RE: WHITEHALL MANOR ~ LOT 39R
621 Canal Lane, Annapolis, MD 21409
Variance Application

Pre-file comments were received from the Office of Planning & Zoning in a memo dated November 12, 2025. A point-by-point response to those comments (*in italics*) is provided below:

VARIANCE PLAN
WHITEHALL MANOR ~ LOT 39R

CONFIRMATION OF PRE-FILE (2025-0104-P)

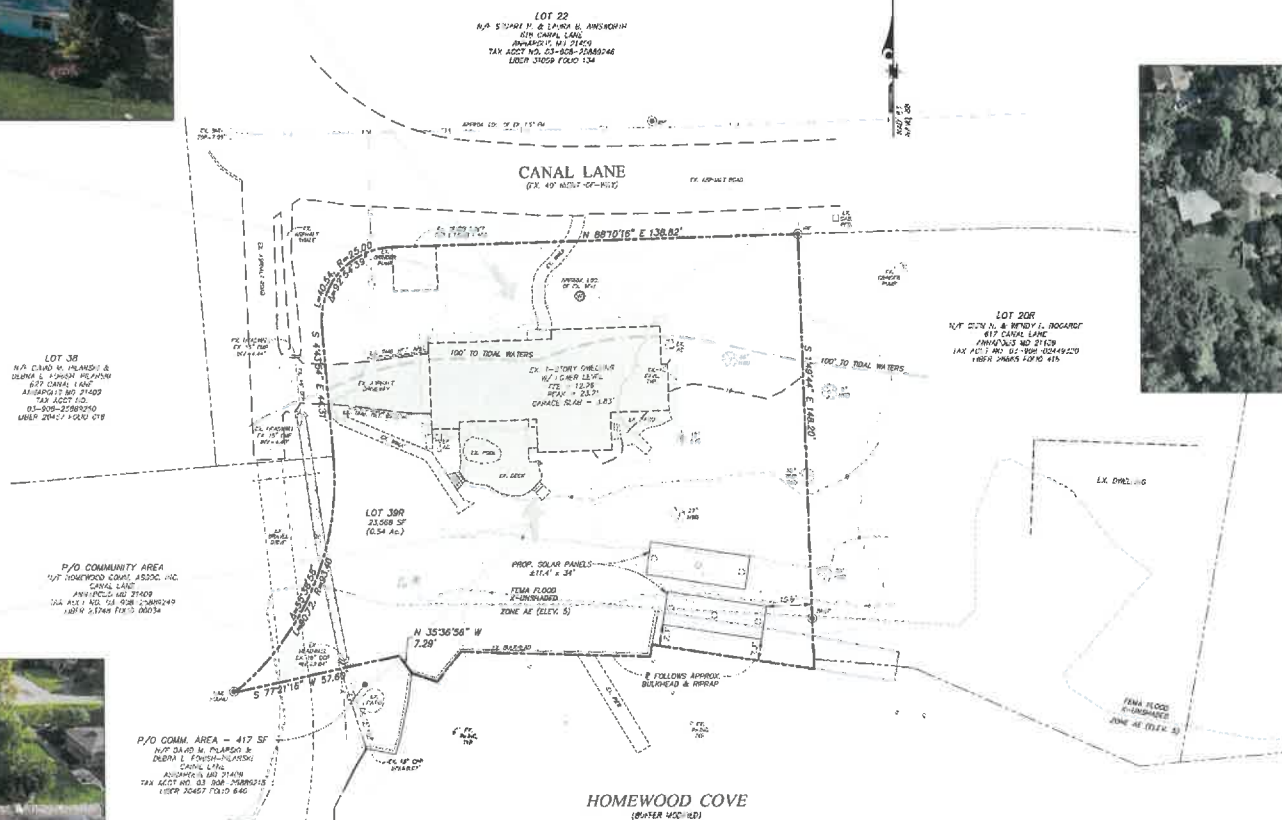
The tree line shown on the plan does not accurately depict the tree line that exists on the site.

The existing trees in this area appear to shade the proposed location of the solar panels.

Any clearing must be shown on the plan.

The dimensions and height of the proposed accessory structures must be shown on the site plan.

- *The full extent of the existing tree canopy areas is now reflected on the site plan.*

- *While part of the existing canopy of the 27" hardwood tree is located above the solar panels, the existing canopy is located high above the ground, such that sunlight still angles onto the solar panels without hitting the tree canopy.*

- *No areas of canopy are proposed to be cleared. Some understory branches may be trimmed in order to ensure that the solar panels receive the maximum amount of sunlight. However, this will not affect the overall canopy area of the tree or its health. All construction for the solar panels and the electrical connection to the dwelling will be performed by hand, with no clearing, grubbing, or grading.*

- *Dimensions and maximum height at maximum tilt for the solar panels are now shown on the site plan.*
